Estimation of Wake Field, Heating in Modified Beam Pipe

Y. Suetsugu, KEK

- Modified Model

Base de données : IDsmt_3D : 23971		Date	14/04/01
Traitement :		Protection :	
Matière :	Tolérances générales	± 0,1	Rugosité générale Ra 3,2 (N)
ILD			
Beam pipe in IP area			
Indice	Date	Modifications	D
Dessiné par : M. JORE			4

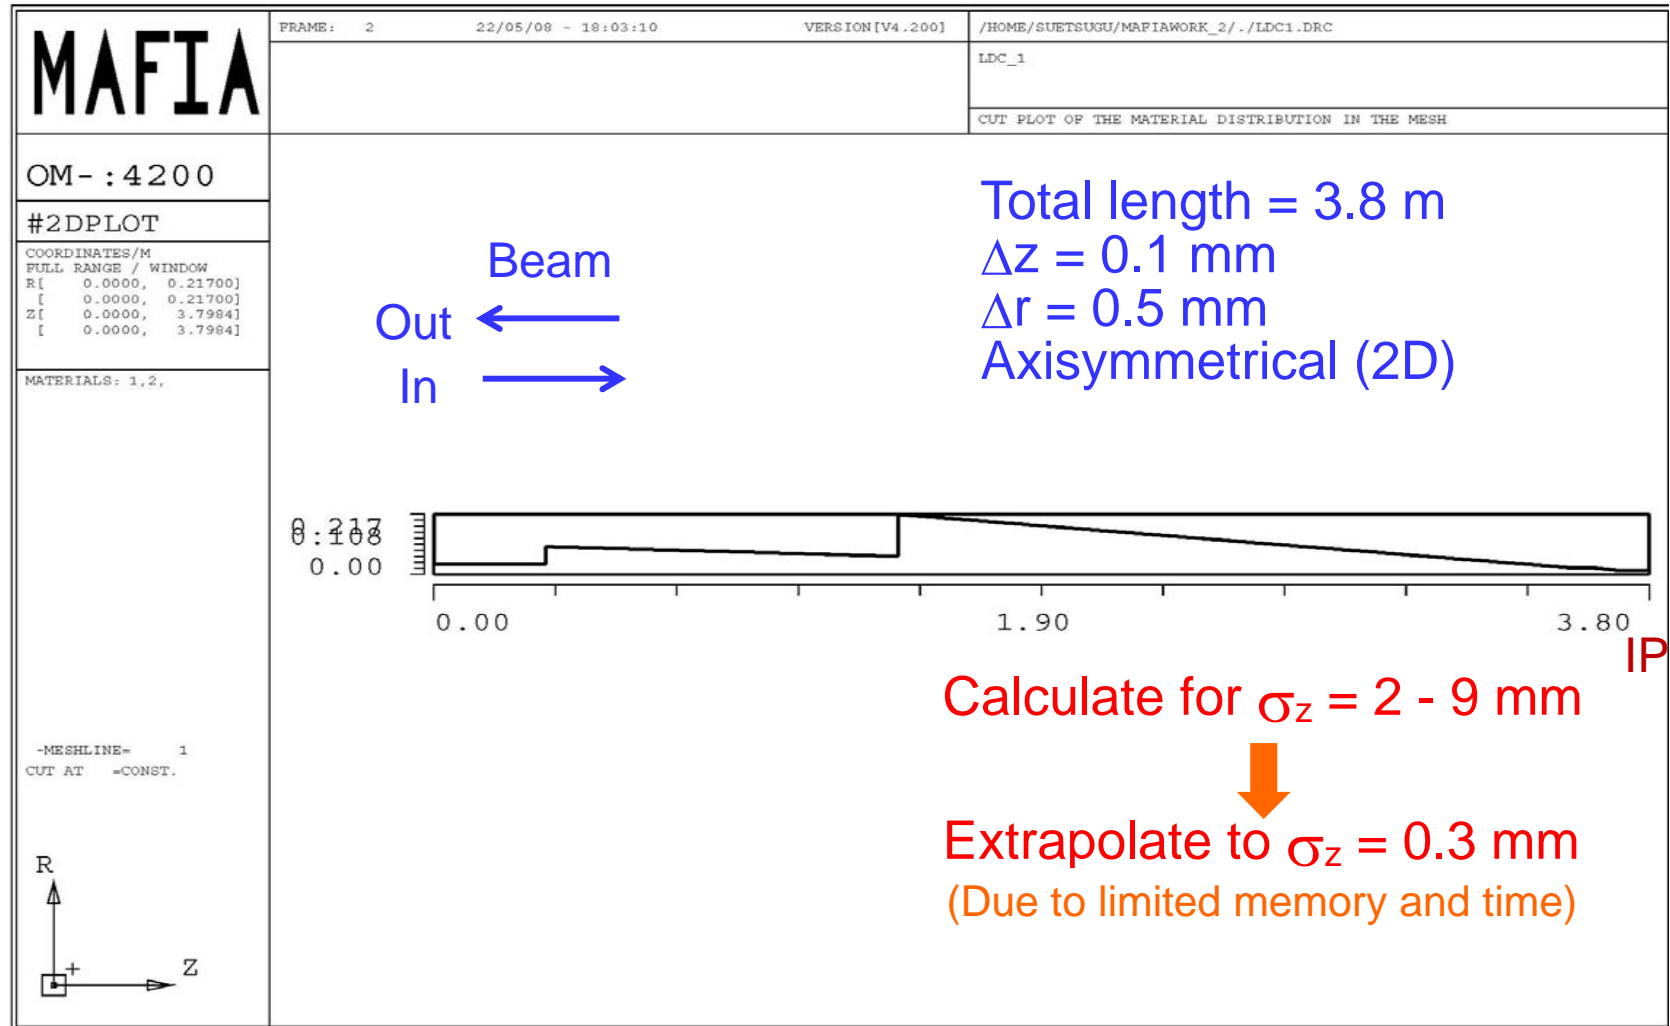
k_{in} and k_{out} is different, since the apertures at both ends are different.

k_{total} (two beams) $\sim 7 \times 10^{13}$ V/C
@ $\sigma_z = 0.3$ mm

$\therefore P = kql = \sim 20$ W (one side)

Almost the same to
the result for LDC-1

- Result: Deformation

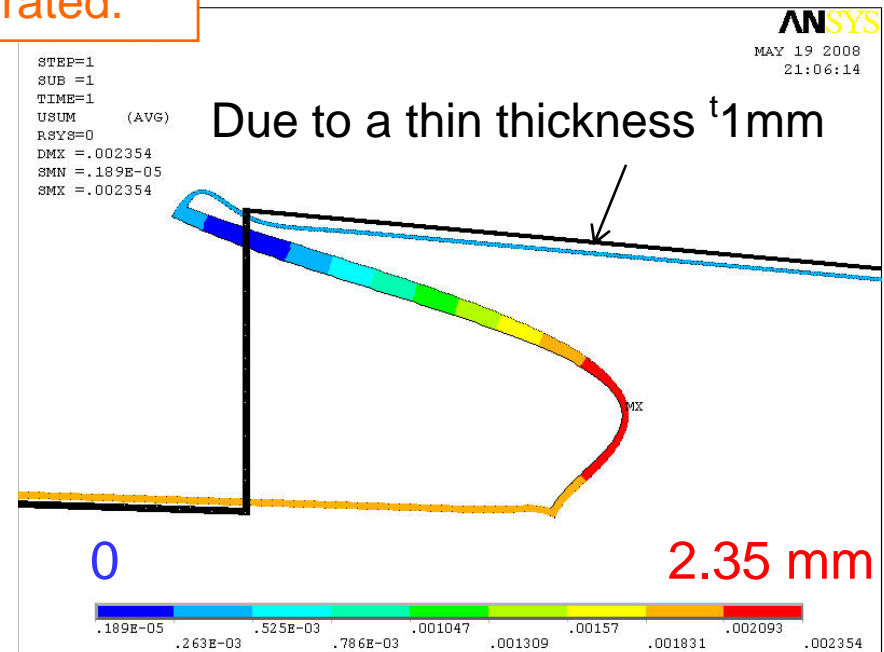
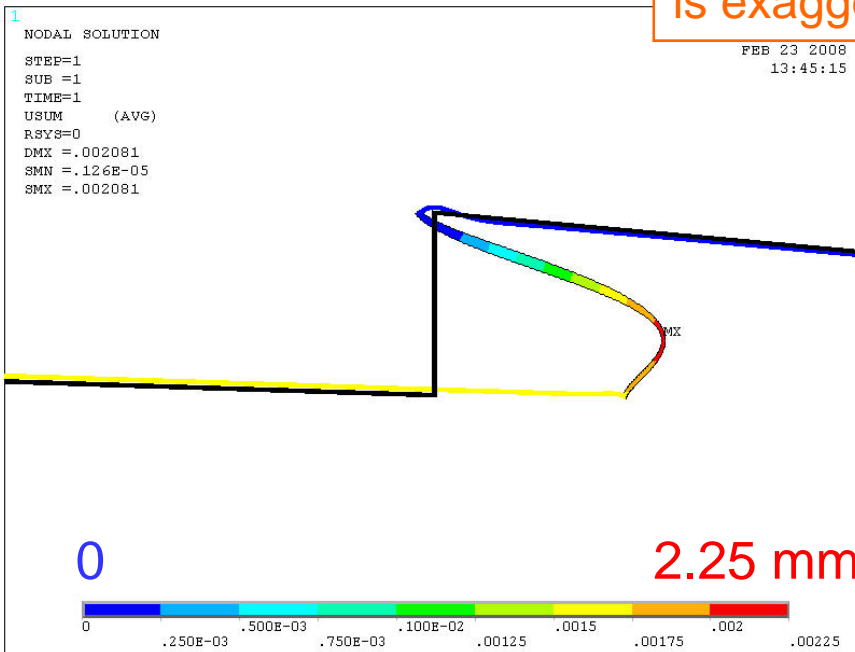
Deformation is a little bit large, but almost the same.

- Result: Stress (Von Mises stress)

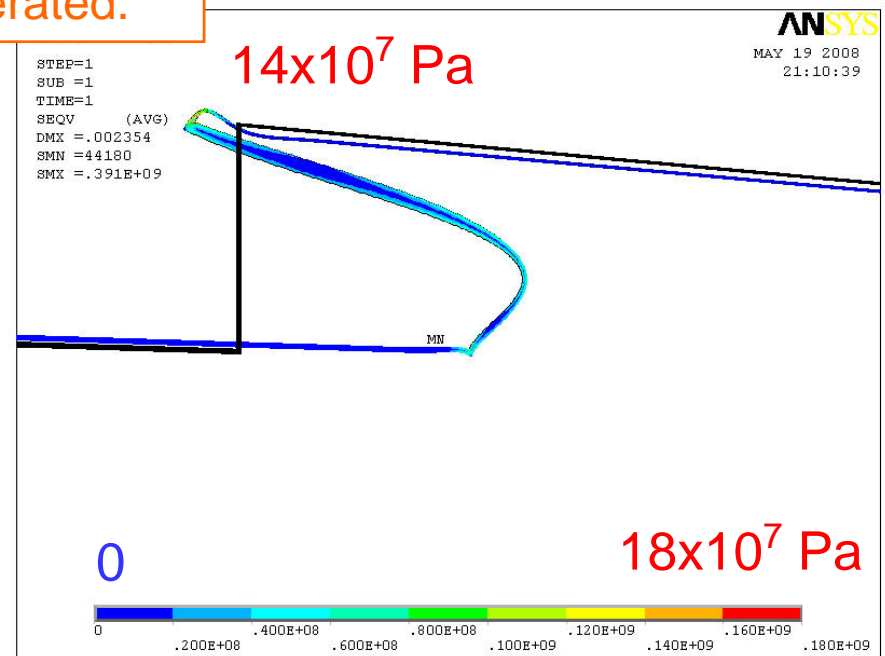
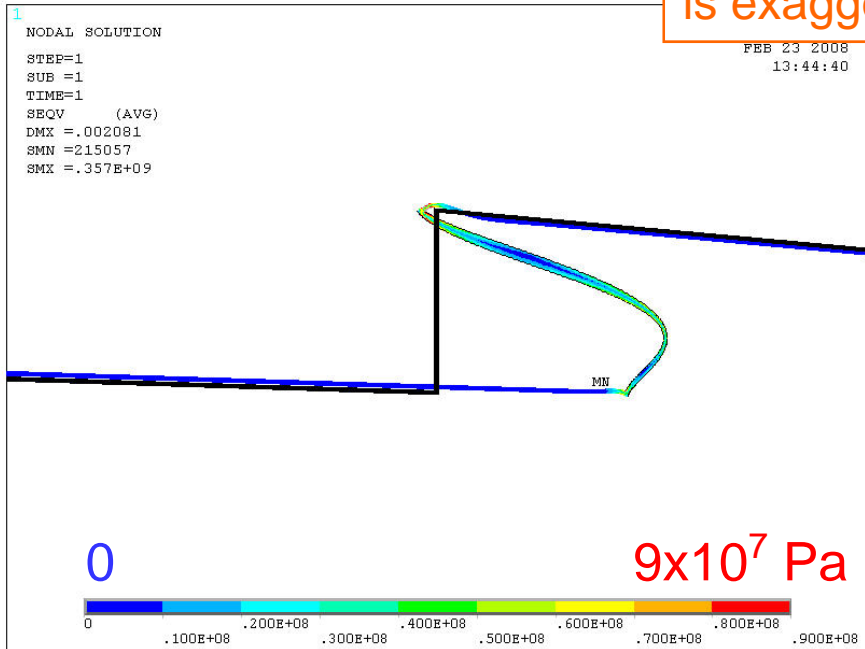
(Yield strength of aluminum alloy is 22×10^7 Pa)
Be careful about the welding at the edge. 1mm?

- Result: Stress (Von Mises stress)(near IP)

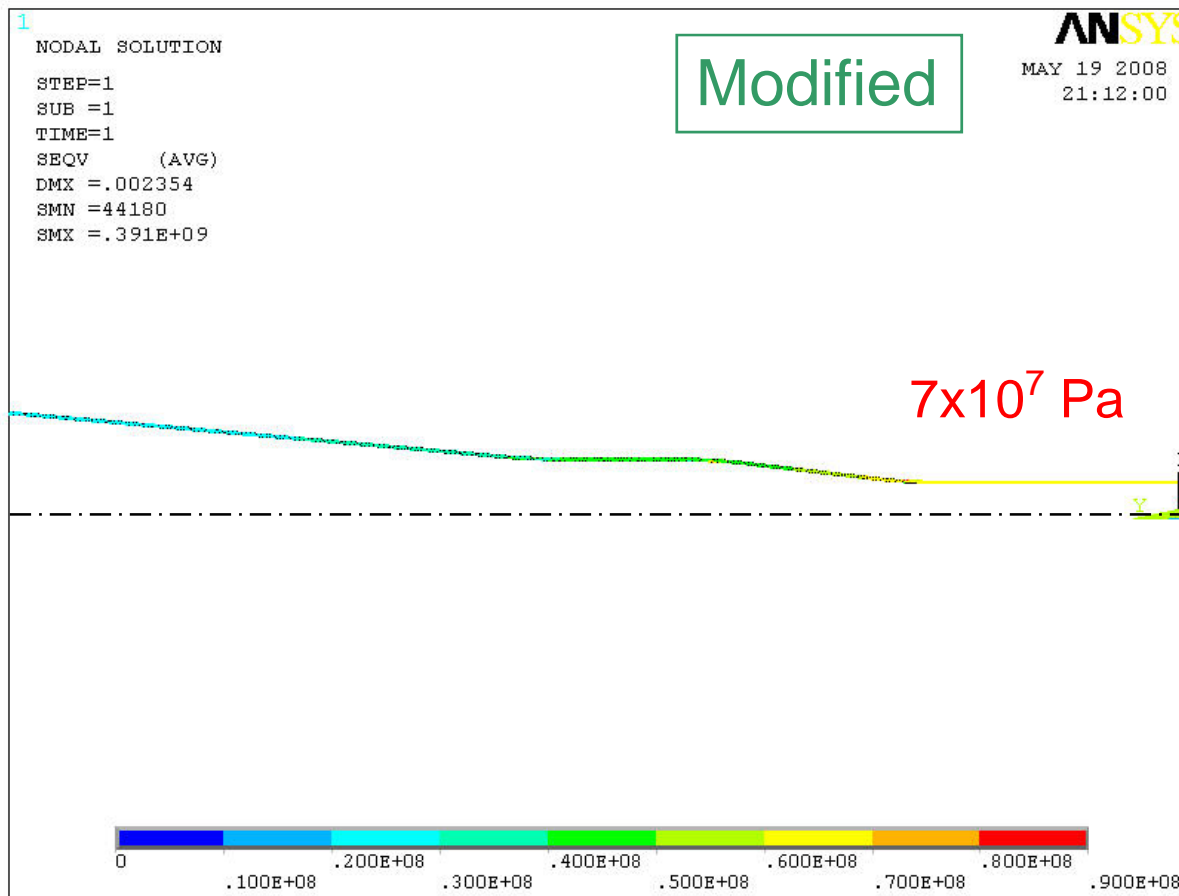
May be no problem

Calculation for actual Be is required.
